# CBM-Caledon Quarry

## CAART COMMENT SUMMARY TABLE RESPONSE #1 – [VISUAL IMPACT]

Initial CAART Comments (March 2025)	Page / Section	Applicant Response (Oct. 30, 2025)	CAART Response (Date)	Applicant Response (Date)	CAART Response (Date)	Applicant Response
<b>Report: Comments on the Visual Impact Assessment prepared by Golder + Landscape Plans by MHBC</b>		<b>Author: J. Fedorowick, Wavefront Planning and Design Incorporated</b>				
<b>Methodology and Accuracy</b>

Location of parking lots from which the northern quarry is visible.

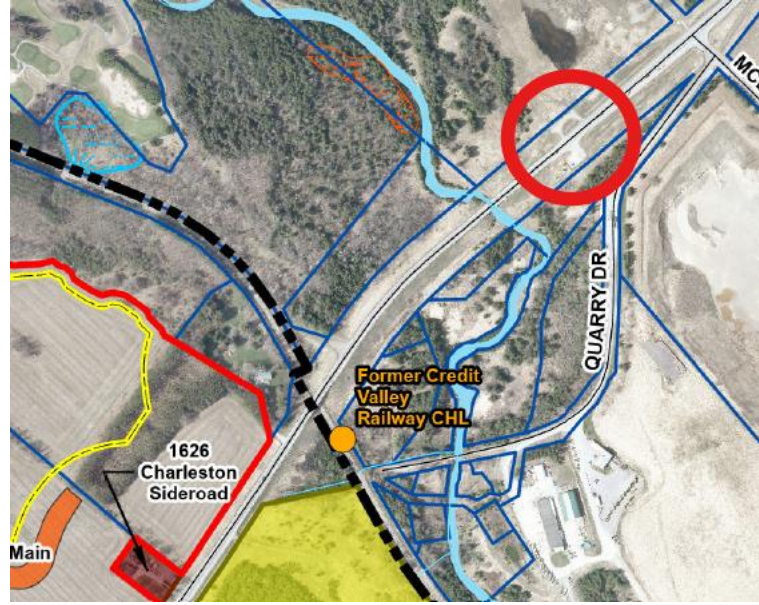
3.	<p>Two viewpoints that offer panoramic and direct views of the extraction area were identified in the field but are not included in the VIA report.</p>	<p>VIA Peer Review Item 5.1, pg. 16</p>	<p>Viewpoints at public parking lots located on both sides of Charleston, northeast of the Credit River will not have a view of the Project. Adding an additional viewpoint at the south boundary of the North Extraction Area on Charleston Sideroad will not change the overall weak contrast rating for the effects assessment.</p>	<p>See attached location at the end of this document ... if you go out to the parking lots shown within the red circle, you can see the hedgerows in the Northern section. What type of mitigation would you propose for this panoramic view?</p>
